Final Drainage Report for
for

Windingwalk Filing 1

at
Meridian Ranch

December 2017

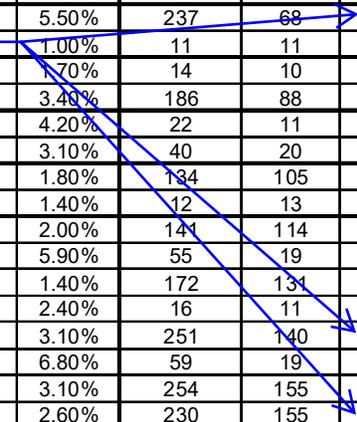
Maximum storm sewer velocity is 18 fps. Update the system design accordingly.

SCS DRAINAGE MAP MERIDIAN RANCH WINDINGWALK FILING 1

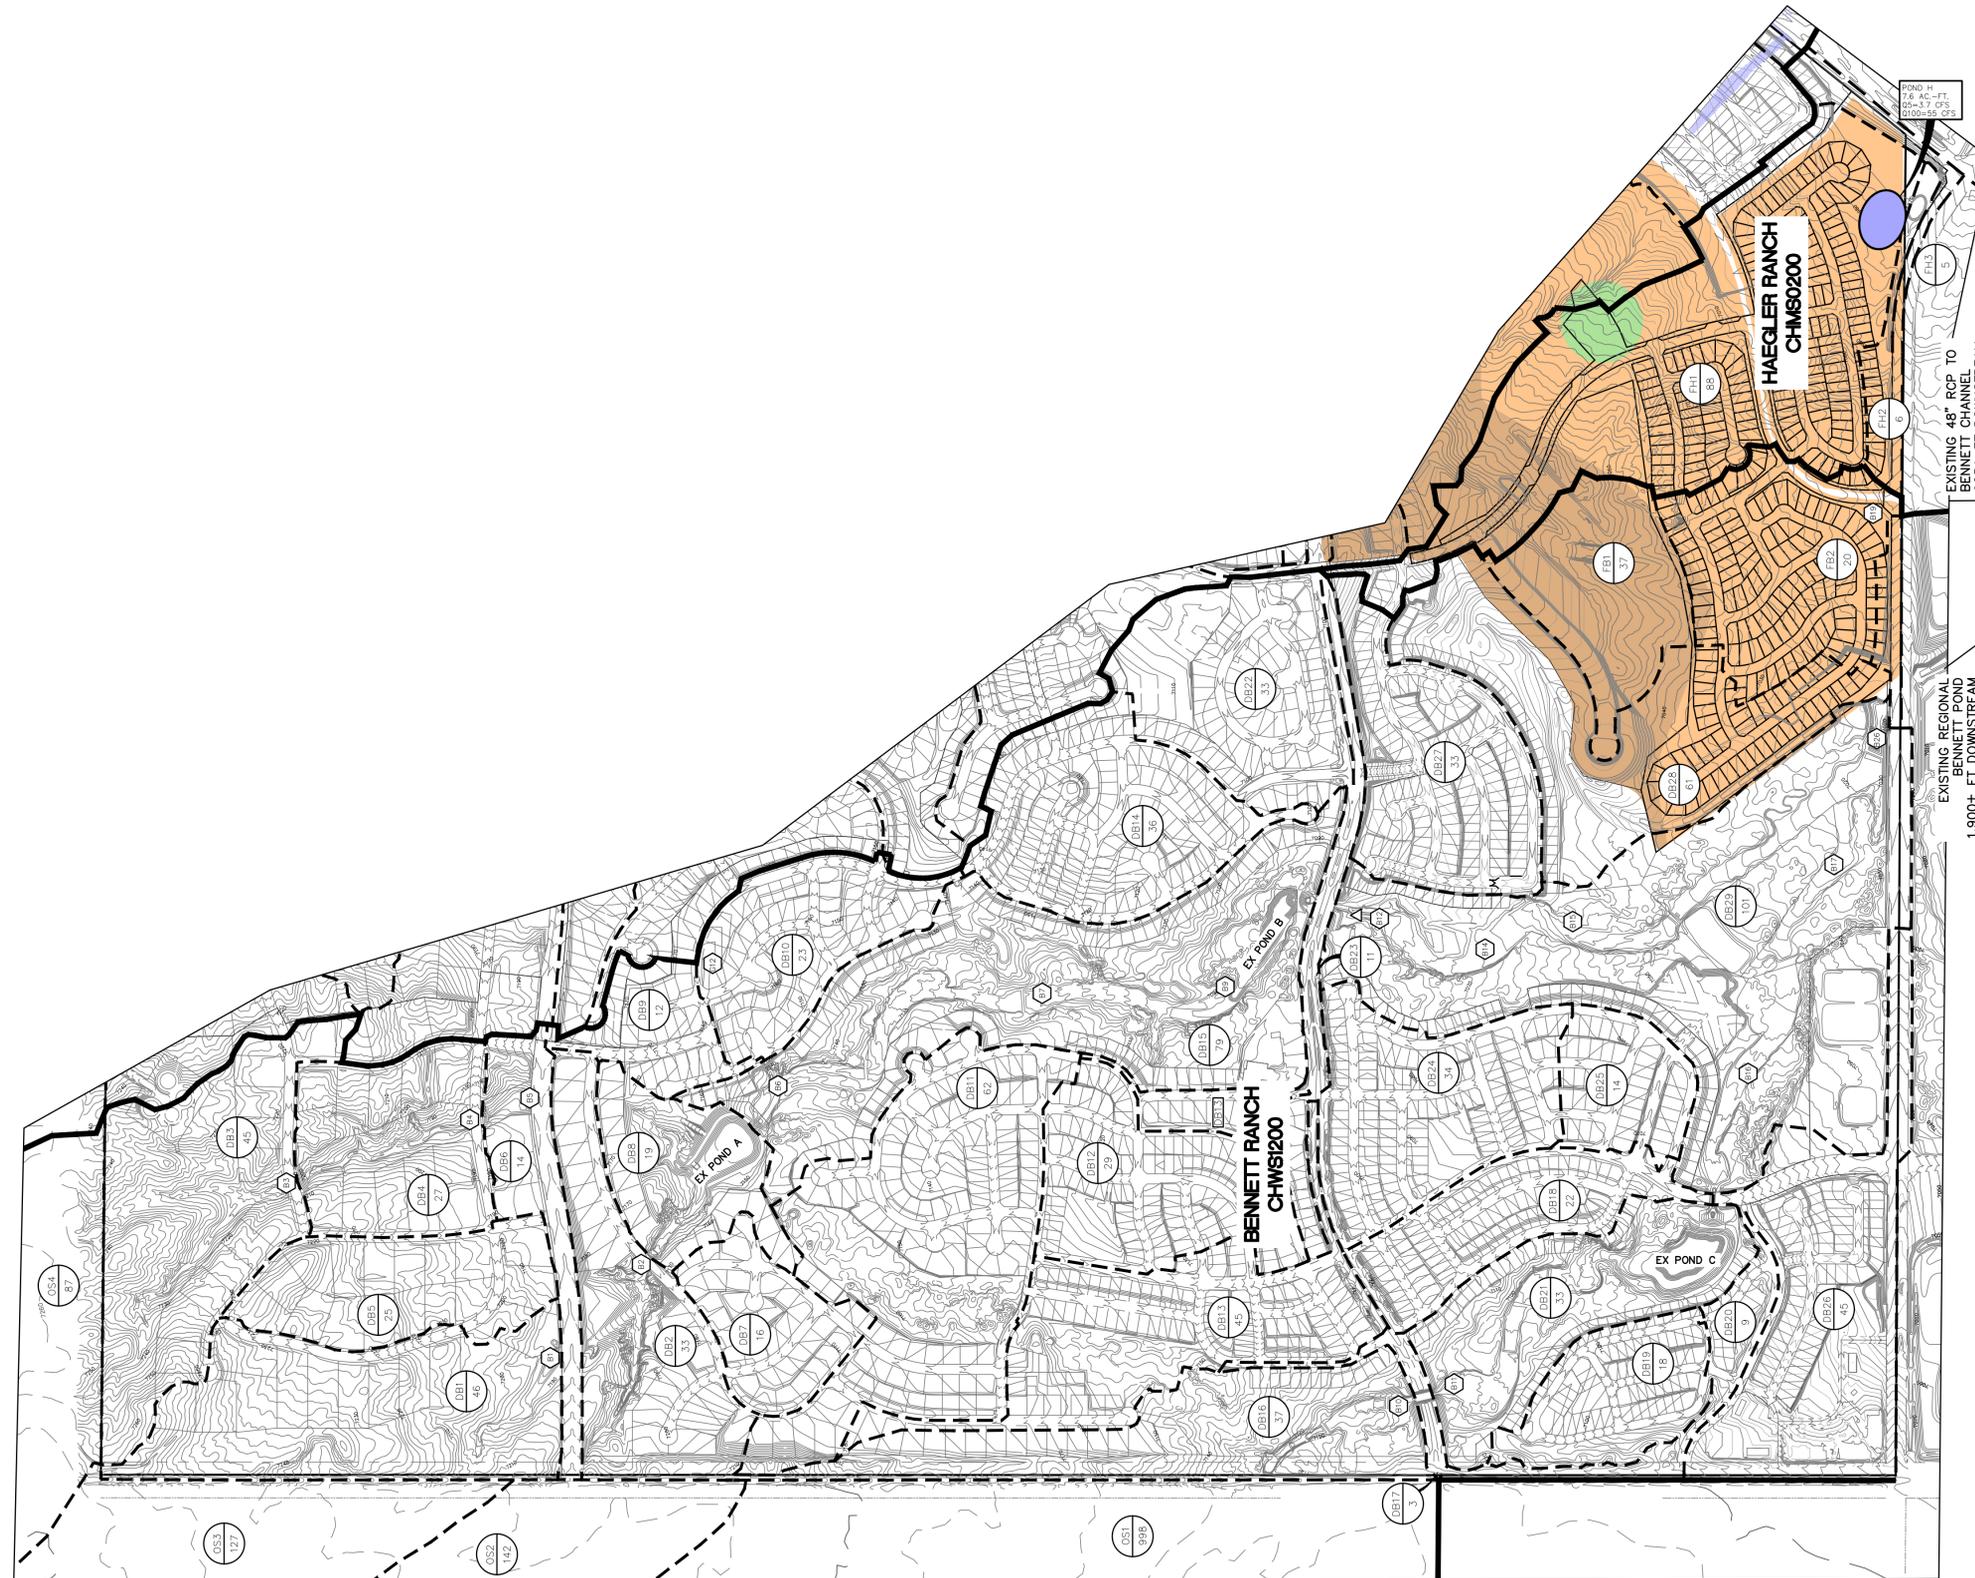
Drainage maps shall provide a summary of all minor and major flow rates at design points.

Show and label the temporary sedimentation ponds noted on page 8

FUTURE CONDITIONS

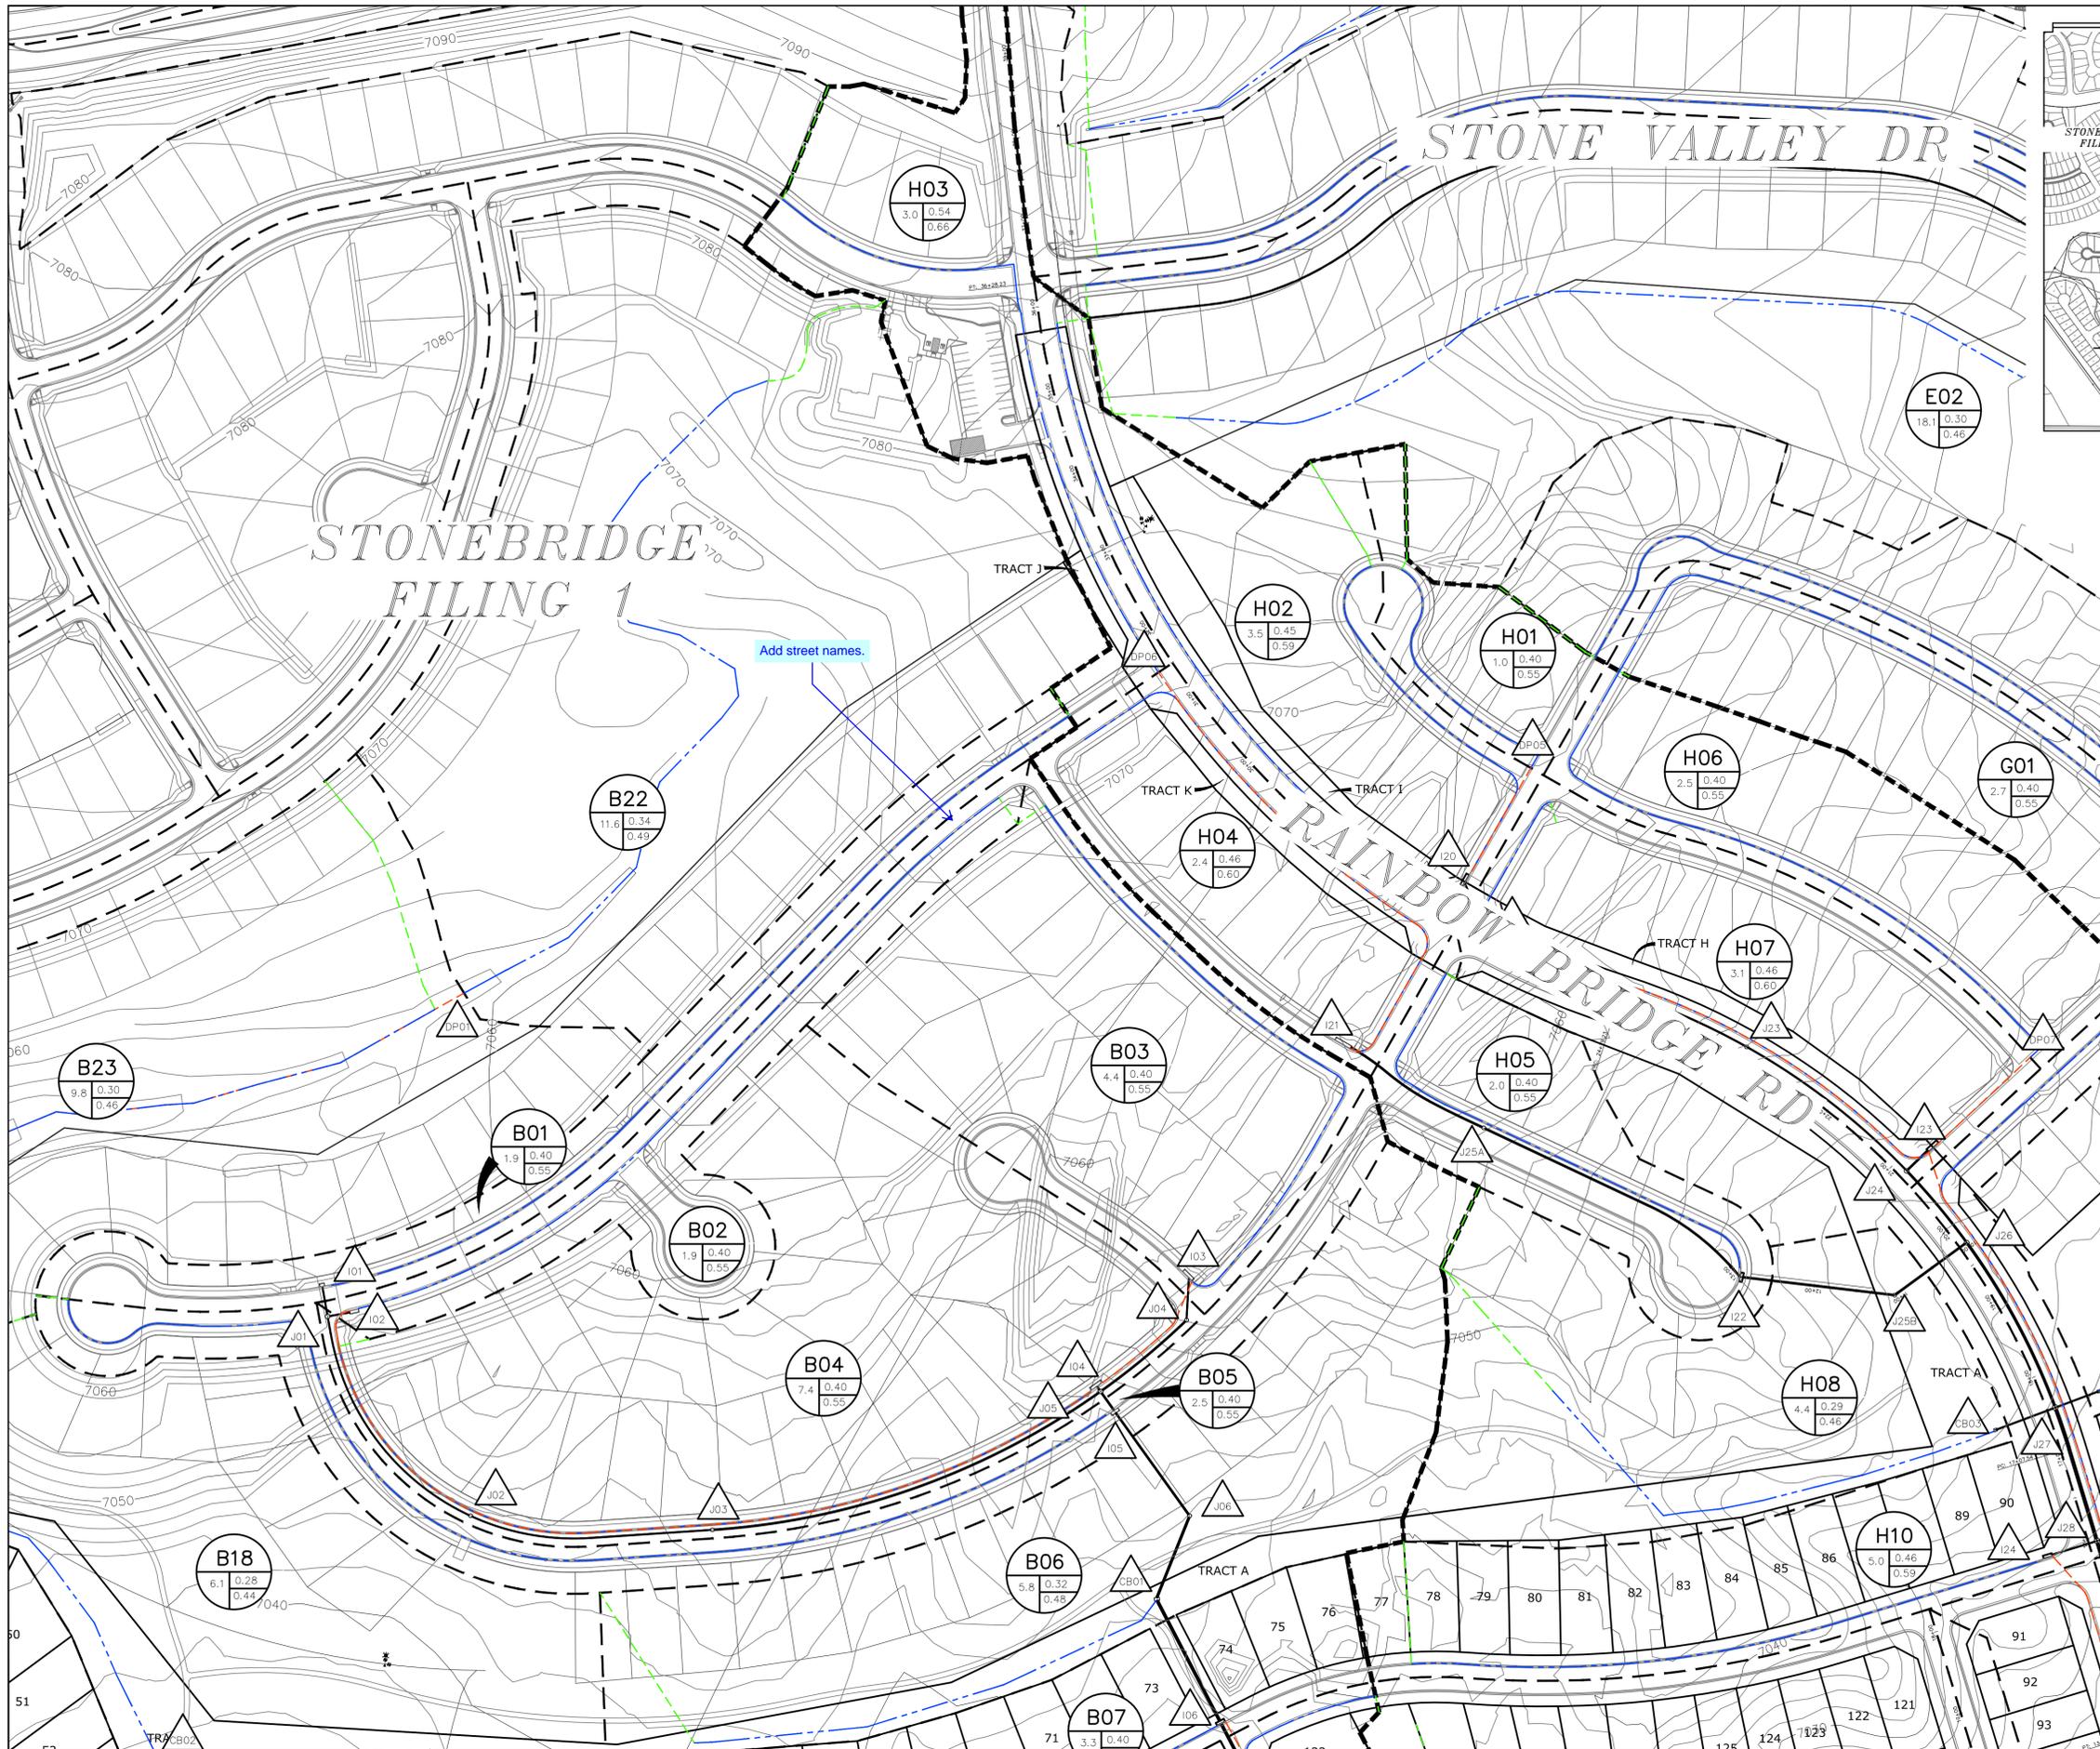
Add a summary of the minor/major flowrates at design points.

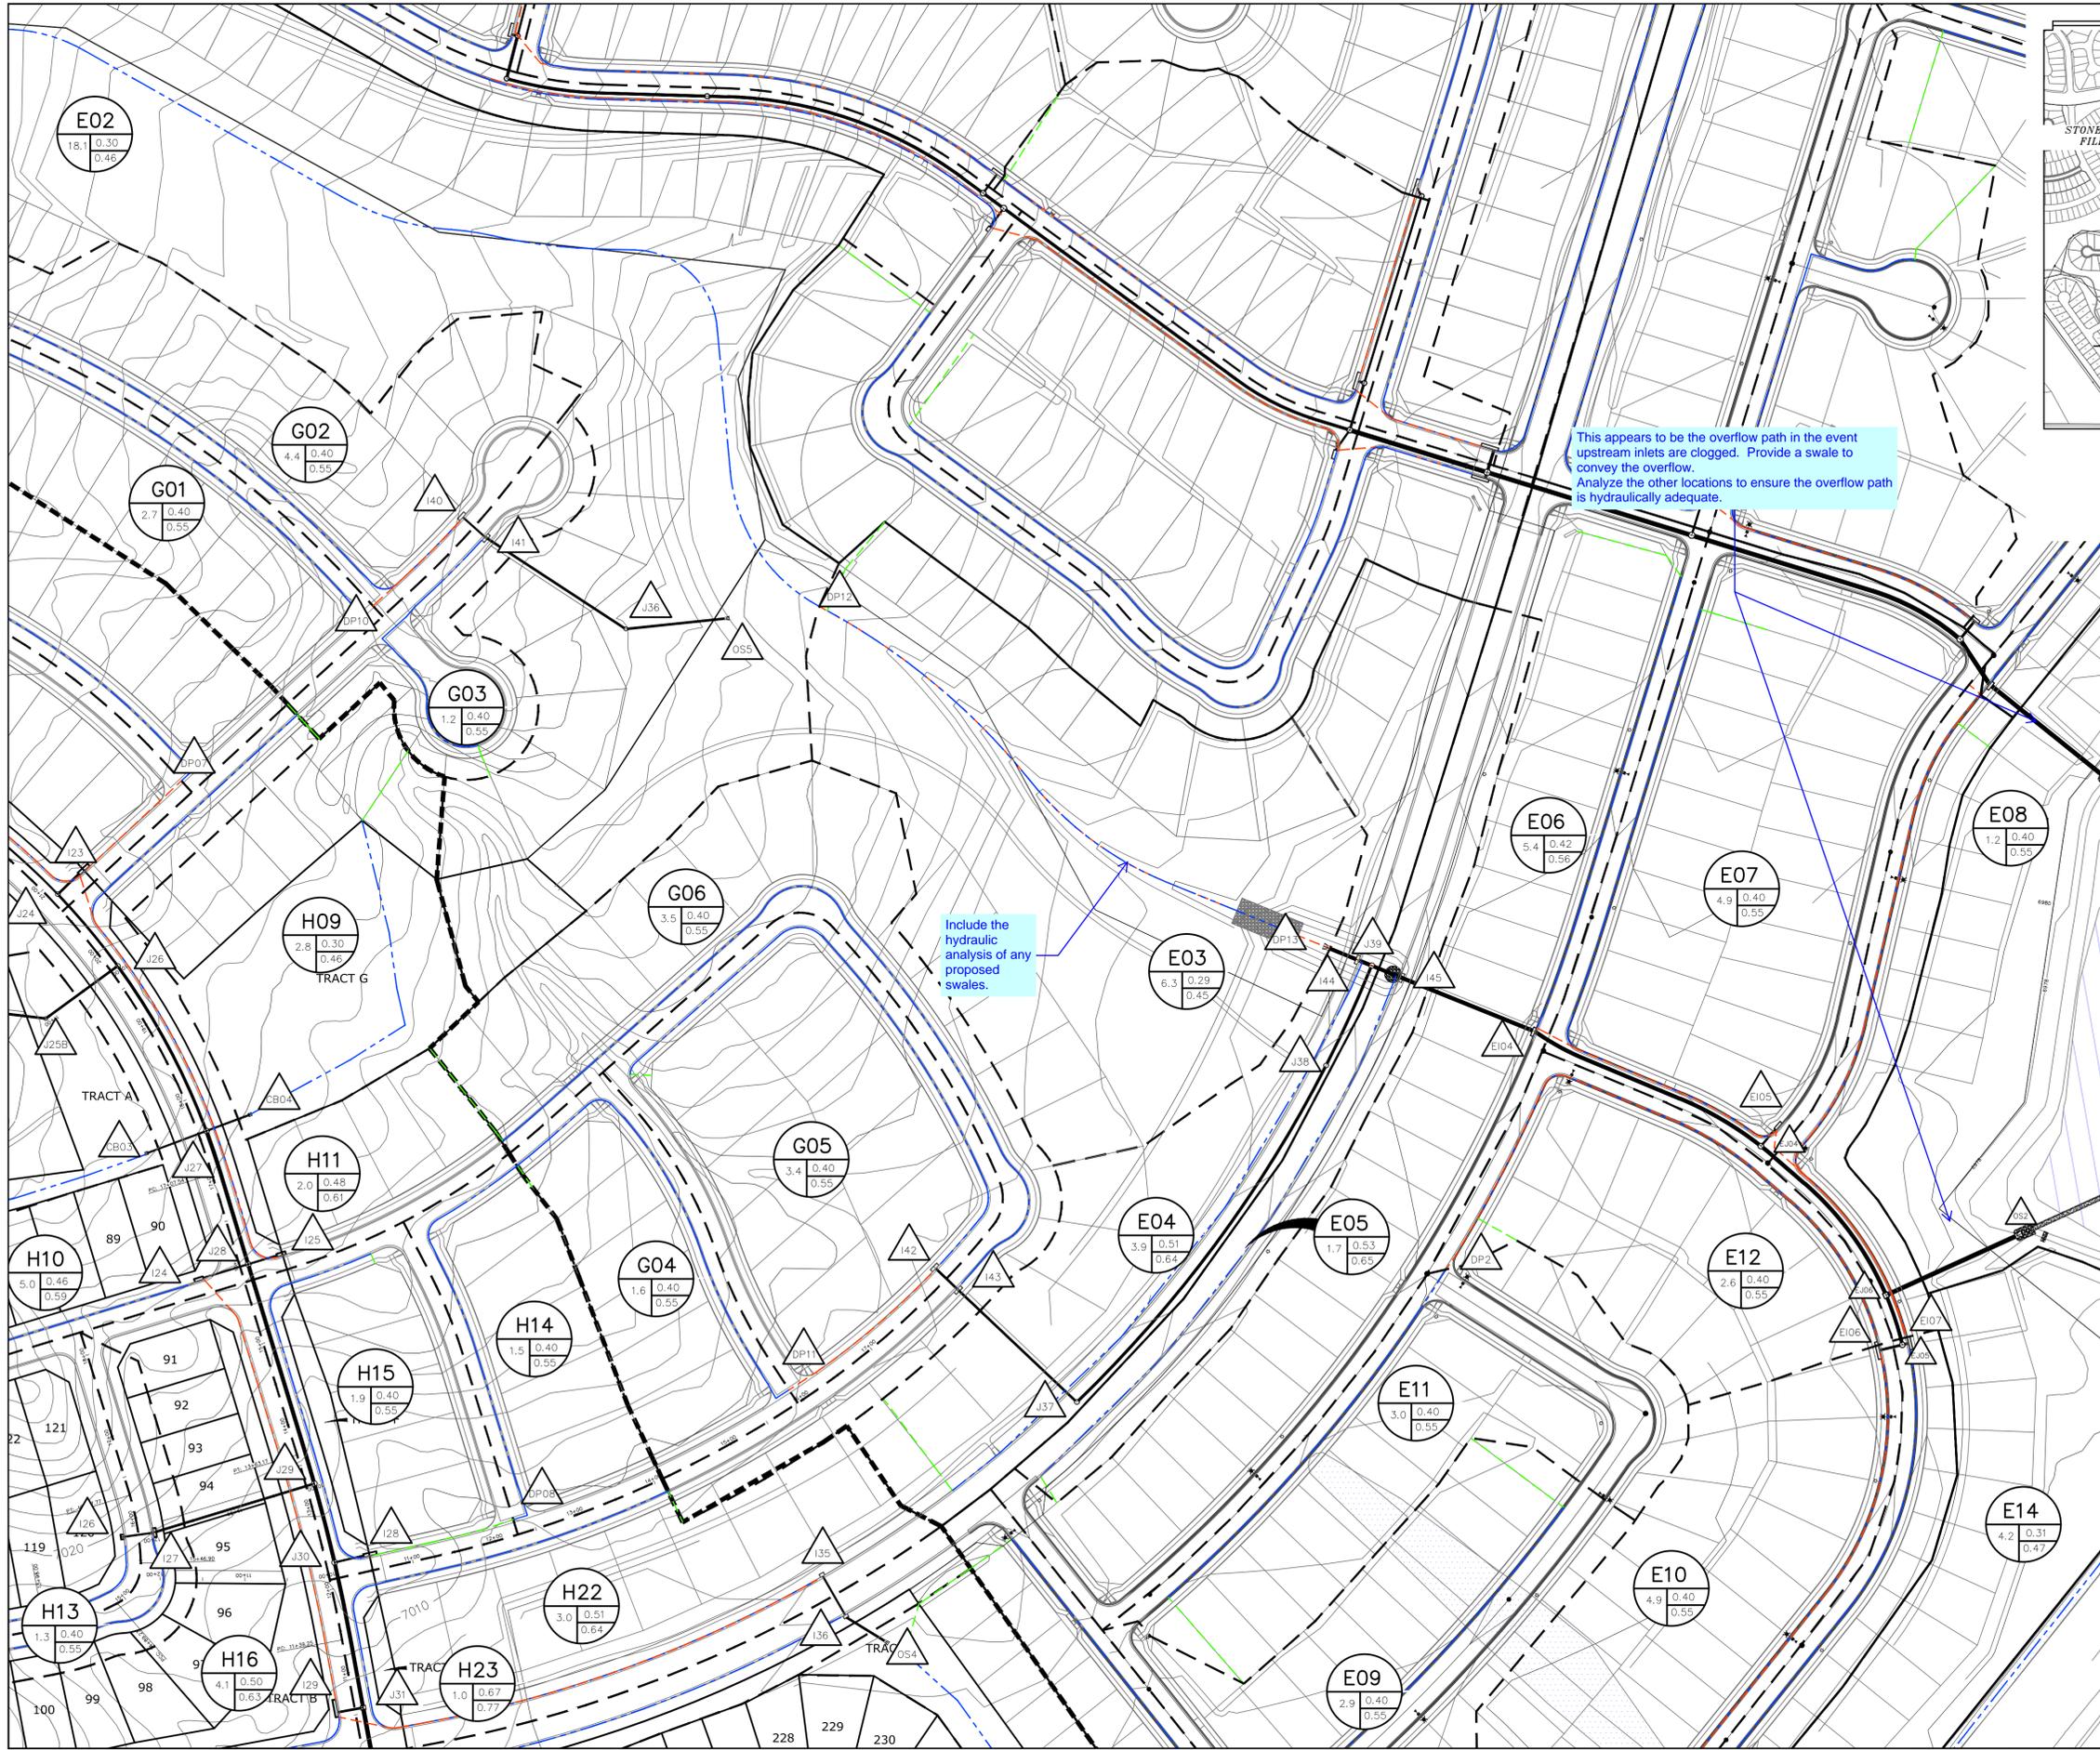
This appears to be the overflow path in the event upstream inlets are clogged. Provide a swale to convey the overflow. Analyze the other locations to ensure the overflow path is hydraulically adequate.

Include the hydraulic analysis of any proposed swales.
